P&WC S.B. No. 41119R4

TURBOSHAFT ENGINE  
IGNITION EXCITER - REPLACEMENT OF

PT6C-67C, PT6C-67C1

**PT6C-74-41119**  
Cover Sheet

Ignition Exciter - Part Progression  
Figure 1

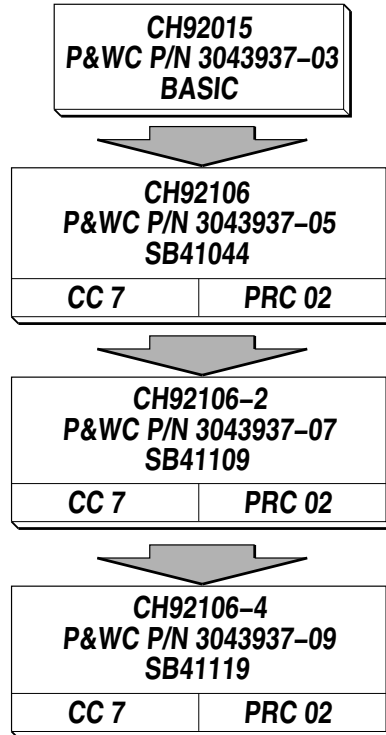
Replace the ignition exciter with one that has an available spider switch.

Replace the ignition exciter with a new one.

<u>New P/N</u>	<u>Keyword</u>	<u>Old P/N</u>	<u>Qty</u>	<u>Est. Unit List Price (\$US, 2021)</u>	<u>Instructions Dispositions</u>
	Ignition Exciter (0AFL4) P&WC P/N 3043937-07	CH92106-2	1		(A)(B)
<a href="#">CH92106-4</a>	Ignition Exciter (0AFL4) P&WC P/N 3043937-09		1	Quote	(A)

(A) TWO WAY INTERCHANGEABLE (ATA200 Explanation Code 02): The old or the new parts can replace the old or the new part.
